13 November 2009
Your Ref: ADC/0074/09

21 Howard Road, Sompting, Lancing, West Sussex. BN15 0LW
Proposed roof extensions

Proposed Front Elevation.

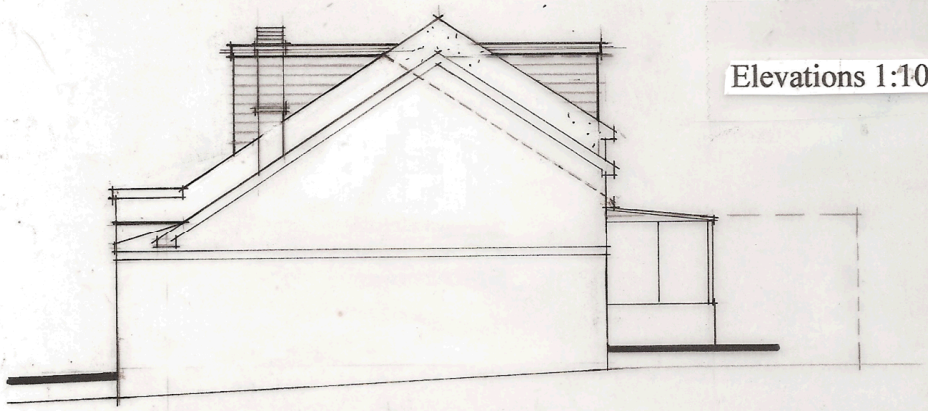
As discussed this window was approved as a 3 pane window to match the window in the first floor roof dormer. It has been found that whether the new window to the lounge is constructed with pvc'u or timber the window manufacturer's will not guarantee the window or the sealed unit double glazing. This is due to the effect that the weight of the opening casement windows (1500mm deep) will have on the hinges and the window frame itself.

Therefore, we would like to change the style of this window still as 3 panes but with top hung vents over the side casements only. I have attached a revised front elevation showing this proposal for your consideration.
